June 30, 2015

Reference No. 1522835-2015-083-L-Rev0-1000

**RESPONSE TO MINISTRY OF ENERGY AND MINES MEMORANDUM DATED FEBRUARY 3, 2015
REGARDING THE FORDING RIVER OPERATIONS TAILINGS STORAGE FACILITIES**

Chart 1: Specified Gradation Envelopes and Specific Samples for Filter Compatibility Assessment

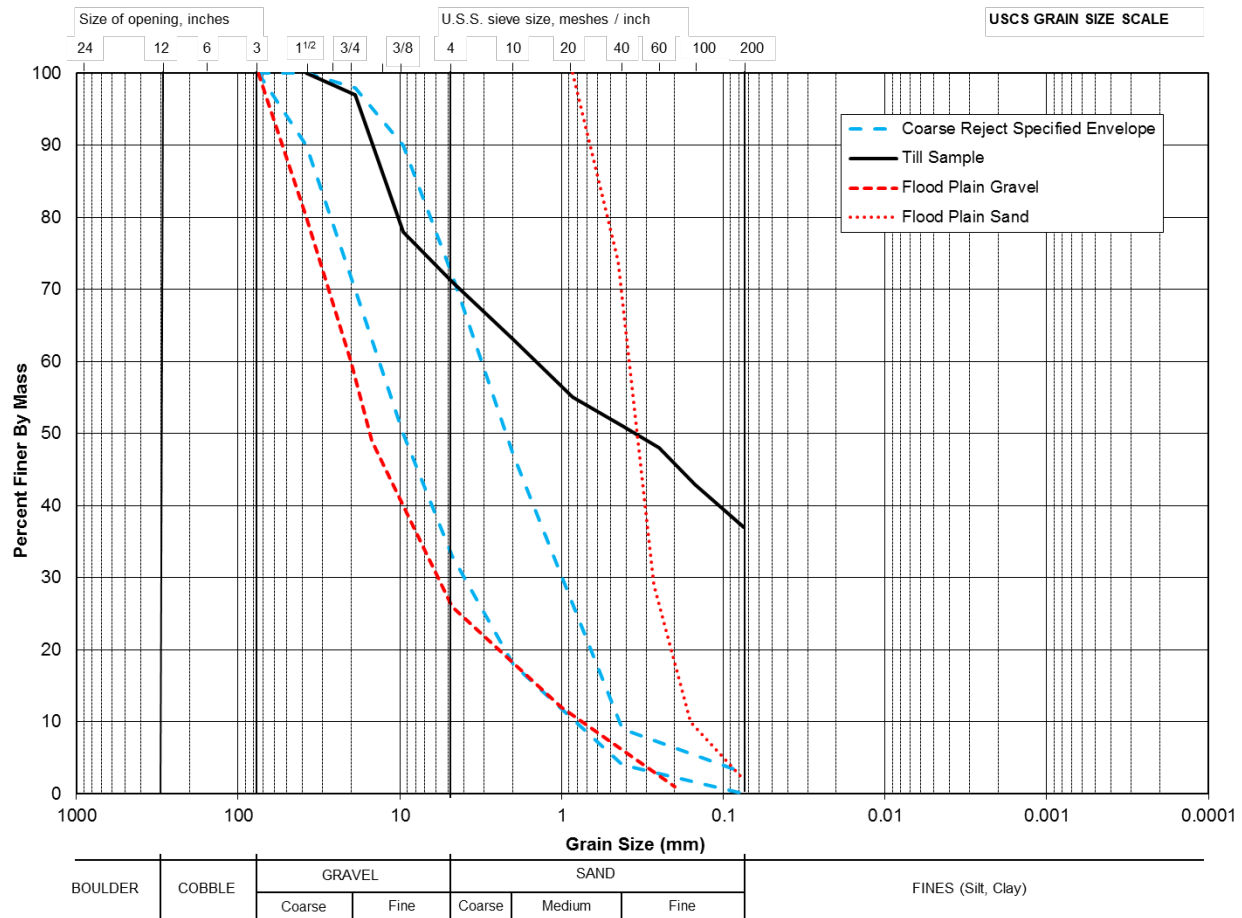
The compatibility between the till (base soil) and the CR shell or flood plain sand and gravel (filter) met the filter compatibility criteria for two of the three methods checked. The internal stability of the CR shell material was confirmed. Based on the seepage performance observed at the NTP dam over the last 45 years along with the current low hydraulic gradients, piping due to filter incompatible materials is considered to be a low risk.

Gradation of the CR material is presented in Chart 1, and it can be noted that the CR material does not always meet the Sherard criteria, as the coarse limit of the envelope has a $D_{15(\text{filter})}$ equal to about 1.5 mm, which exceeds the specification of 0.7 mm. However, Golder (1973) included an assessment that demonstrated the breakdown of the CR material during compaction, which reduced the $D_{15(\text{filter})}$ of the material from 0.95 mm to 0.68 to 0.57 mm (within specification).

Gradation of the expected range of foundation sand and gravel materials is presented in Chart 1, and it can be noted that the coarse limit of the flood plain gravel does not meet the Sherard criteria, as the $D_{15(\text{filter})}$ of the gravel is about 1.5 mm, which exceeds the specification of 0.7 mm. However, the flood plain gravel is generally mixed with the flood plain sand, which would reduce the effective $D_{15(\text{filter})}$ size.

The compatibility between the till (base soil) and the CR shell or flood plain sand and gravel (filter) met the filter compatibility criteria for two of the three methods checked. The internal stability of the CR shell was confirmed. Based on the performance of the dam over the last 45 years, piping due to filter incompatible material is not expected to be an issue.

The gradation of the underlying flood plain sand and gravel should be confirmed via sampling from the planned 2015 drilling program.

Chart 2: Specified Gradation Envelopes and Samples for Filter Compatibility Assessment

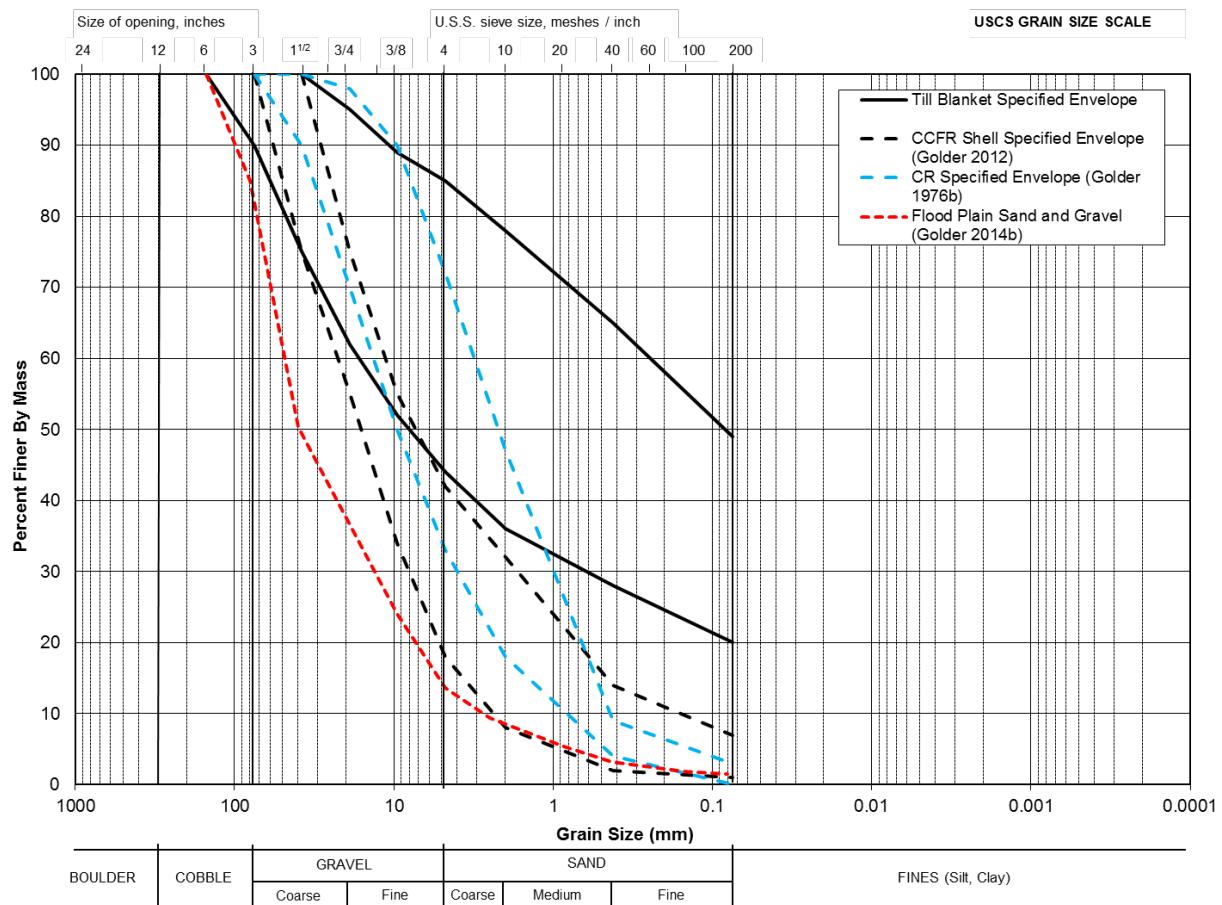
The compatibility between the till (base soil) and the CR/CCFR shell or flood plain sand and gravel (filter) met the filter compatibility criteria for two of the three methods checked. The internal stability of the CR/CCFR shell was confirmed.

Gradation of the CR and CCFR materials are presented in Chart 2, and it can be noted that the materials do not always meet the Sherard criteria, as the coarse limit of the envelopes has a $D_{15(\text{filter})}$ which exceeds the specification of 0.7 mm. Breakdown of the CR and CCFR materials occurs during compaction, which is expected to reduce the $D_{15(\text{filter})}$ of the material somewhat, but some materials may still not meet the Sherard criteria.

Gradation of a sample of flood plain sand and gravel is also presented in Chart 2, and it can be noted that the materials do not always meet the Sherard criteria, as the $D_{15(\text{filter})}$ of the sand and gravel is about 5 mm, which exceeds the specification of 0.7 mm. The $D_{15(\text{filter})}$ of the flood plain sand and gravel was identified as being between 0.1 mm and 1.0 mm in KWL (1976), which is closer to meeting the criteria.

Based on the performance of the dam over the last 37 years, piping due to filter incompatible materials is not expected to be an issue. Continual seepage is evident at the toe of the STP dam, particularly along the West Dam, and has been reported for many years. Cloudy seepage water can indicate internal erosion, but records of the seepage from the STP indicate clear water. Regular inspections for evidence of increased seepage and piping should continue. Seepage from the STP dams should be collected as per the recommendation in the 2014 annual dam safety inspection (Golder 2014c) and monitored for particulate prior to the 2016 freshette.

The seepage from the STP dams should be collected as per the recommendation in the 2014 annual dam safety inspection (Golder 2014c) and monitored for particulate prior to the 2016 freshette.
